*The*  
**University of Oklahoma**

DEPARTMENT OF RADIOLOGICAL SCIENCES  
College of Medicine

With reference to our recent telephone conversation related to the teletherapy, education, and training unit and NRC License No. 35-03176-06 for the Co-60 unit located in the O. U. College of Health, the pertinent information for the questions asked by you is provided below:

| SUBJECT<br><div style="font-size: 1.2em;">Deficiencies Identified During Review of 1/29/85 Survey Report</div>  |  |   |  |  |  |   |  |   |  |

CHB RM 49  
 SCALE:  $\frac{1}{4}'' = 1'0''$

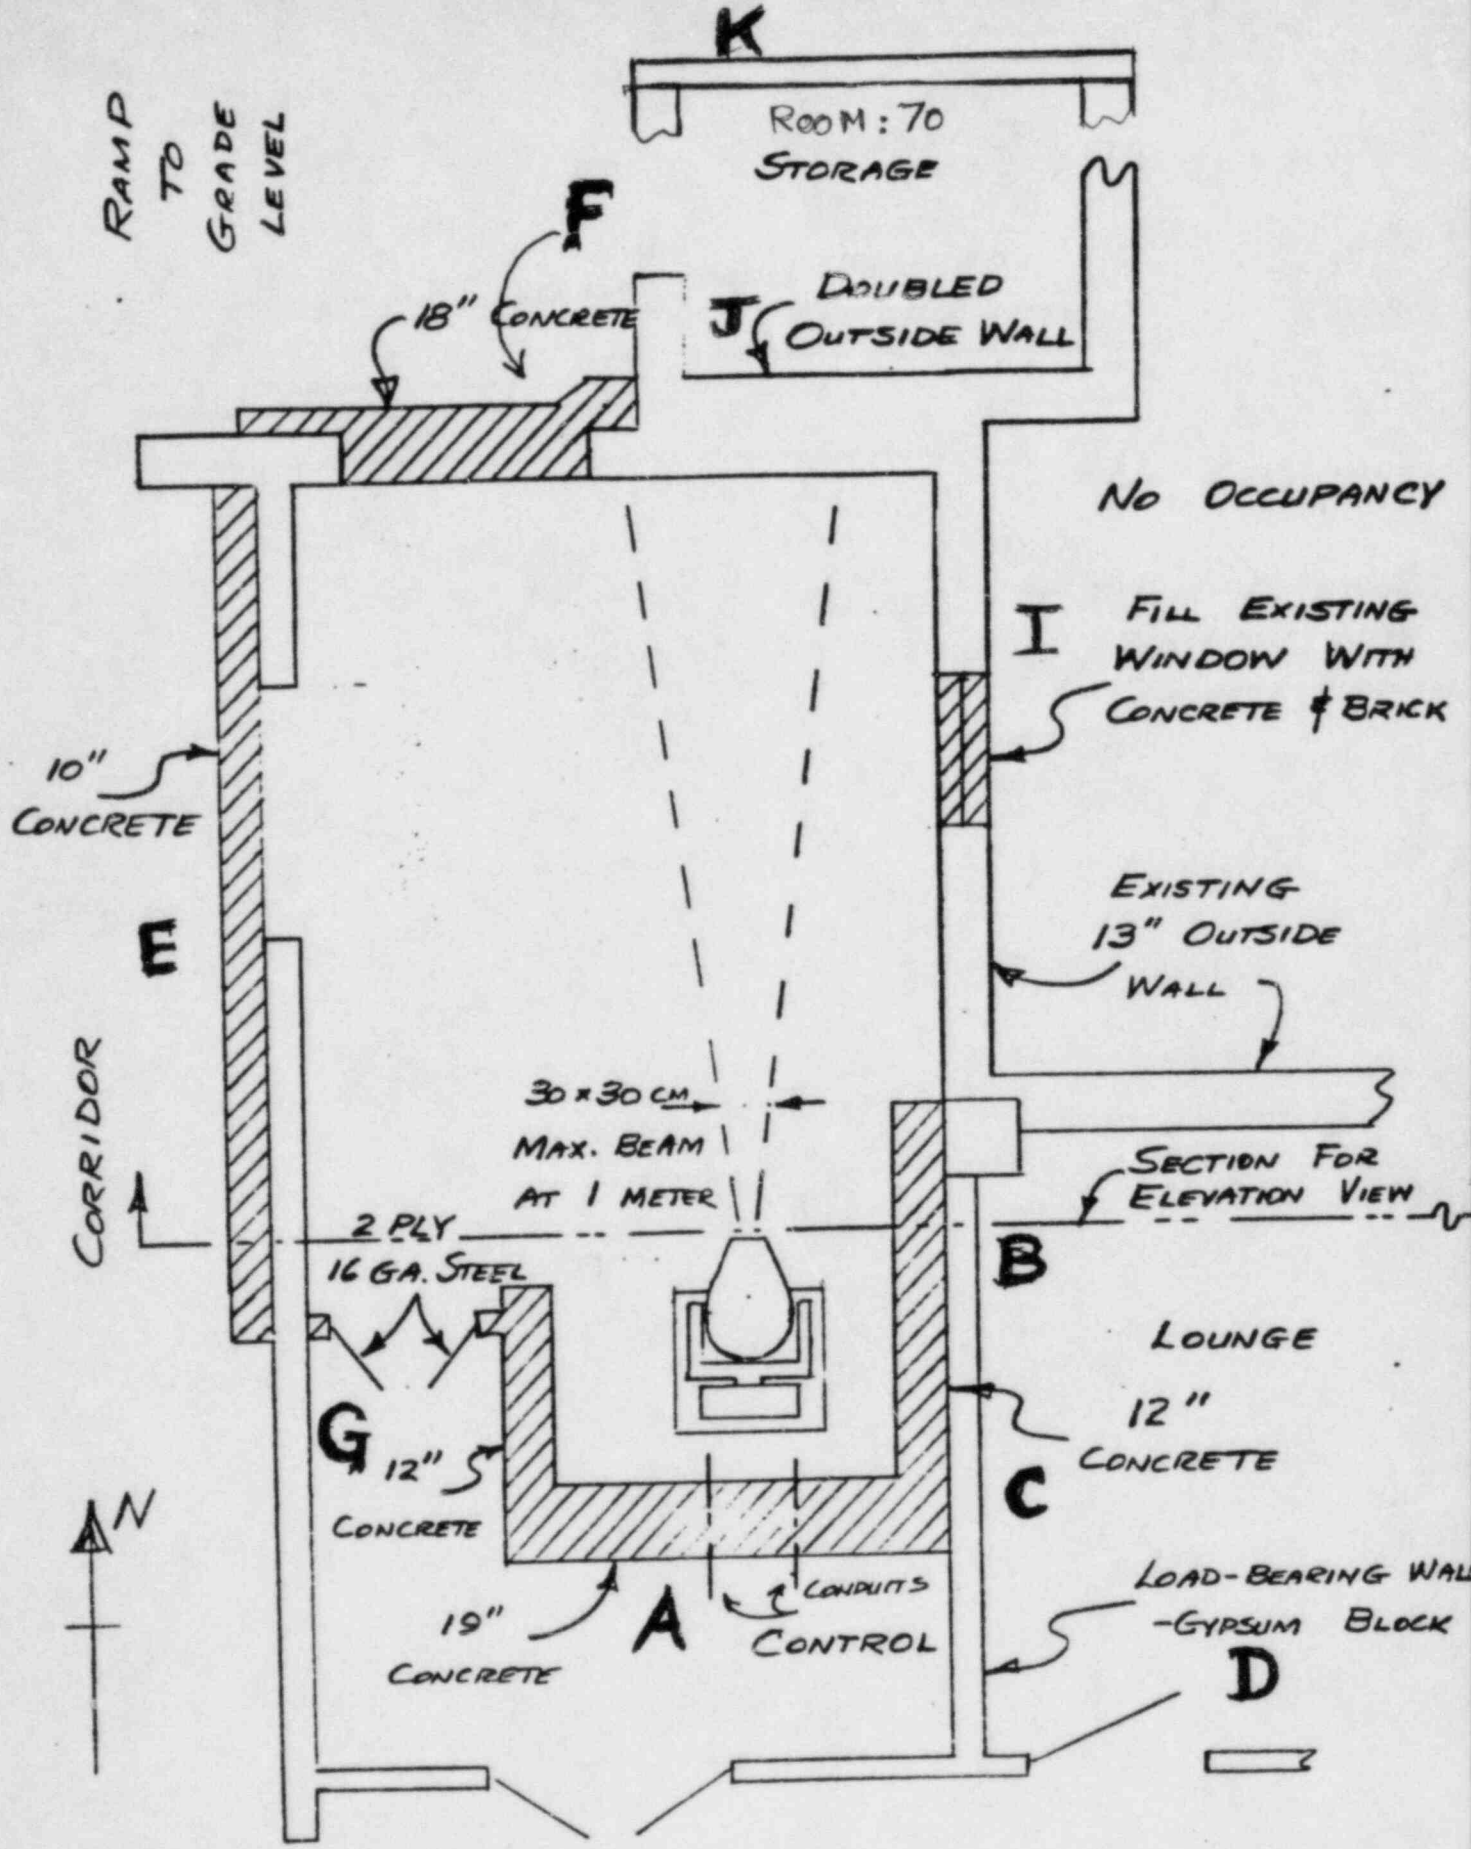
| SUMMARY<br><div style="margin-top: 10px;"> <ol style="list-style-type: none"> <li>1. The licensee will rotate head to the north wall and make surveys of roof, north wall exterior, and adjacent wall exteriors <u>or</u> install microswitch on device to prevent head rotation and to maintain vertical down orientation.</li> <li>2. Licensee will describe phantom used in previously submitted measurements (pressboard).</li> <li>3. Licensee stated that device use began in February 1985.</li> <li>4. I indicated that conditions 20. and 21. would be amended or deleted after review of data to be submitted.</li> <li>5. Response will be mailed by 3/4/85.</li> </ol> </div> |  |   |  |  |  |   |  |   |  |

1. The area survey with the head at  $90^{\circ}$ , i.e. pointing towards the north wall, has been performed. The exposure levels at pertinent locations are provided in the attachment. The locations where exposure measurements have been made are indicated on the sketches provided.

These measurements were made with a 20 cm thick pressed wood phantom in the field of view.

(A) The exposure at location J is 85 mR/hrs for the beam pointed towards north wall. There is a concrete wall on the outside. However, the height is about 5 ft. 5 inch.

The room no. 70COH has been assigned to the Office of Radiation Safety for storage of de-classified waste. The room will be locked and the key will be used only by the personnel of the O. U. Office of Radiation Safety. No personnel is going to be present there on a regular basis. All the personnel wear film badge dosimeters. Access to the area is restricted. This area may be considered a controlled area.

Exposure level on the outside wall is 4.8 mR/hr, considering 10% use factor the exposure will be 0.48 mR/hr. This wall is in the parking area where occupancy near the wall will be quite limited.
